RE: Initial Submission Review – Fairways at Lowry (One Dayton Village)
Case Number: 1969-4001-09
HKS Project No. 210433

Enclosed herein is the comment response letter for the Initial Submission Review for Fairways at Lowry. The initial review comments that were provided on July 27, 2021, have been addressed and are included with this letter.

FENCE PLAN/SHEET L2.10:

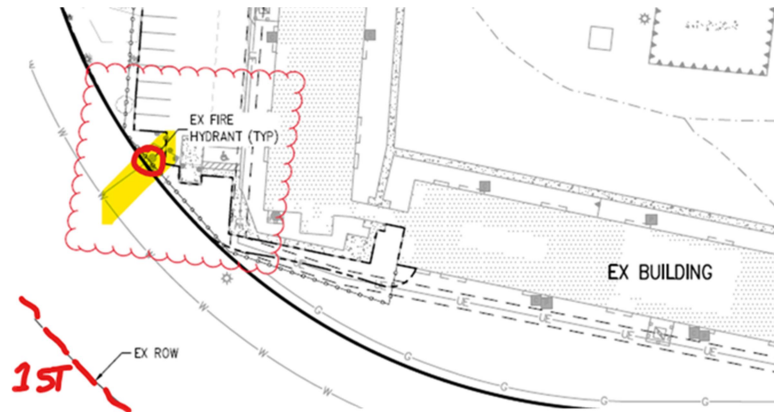
- See comment related to clearance under gates.
- *Response: Acknowledged, gates have been adjusted to maintain proper clearances.*
- See comment related to Knox box location on details.
- *Response: Acknowledged, knox boxes have been added in locations compliant with fire code.*
- See comment related to accessible components/means for gate details.
- *Response: Acknowledged, gate hardware has been labeled as ADA compliant and panic hardware has been added on the inside of all perimeter gates.*
